**Environmental  
Protection Agency**

July 19, 2011

RE: CUYAHOGA COUNTY  
CITY OF MIDDLEBURG HEIGHTS  
MCDONALD'S RESTAURANT  
NPDES PERMIT NO. OHC000003  
OHIO EPA PERMIT NO. 3GC05329\*AG  
CONSTRUCTION STORM WATER

Figure 1. Preexisting catch basin along the construction drive with no inlet protection.

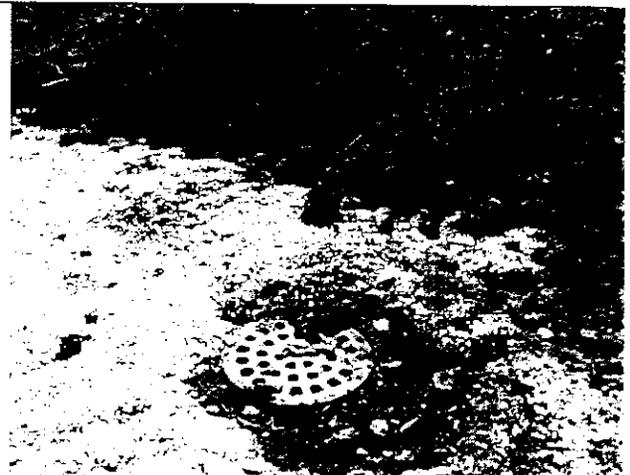
- There appeared to be several unprotected preexisting catch basins throughout the site, specifically along the construction drive near the construction trailer, and near the soil piles on the side opposite Bagley Road. Please be sure to install proper inlet protection as specified in the Storm Water Pollution Prevention Plan (SWP3) to prevent sediment laden water from discharging to surface waters of the state (See Figures 1 & 2).
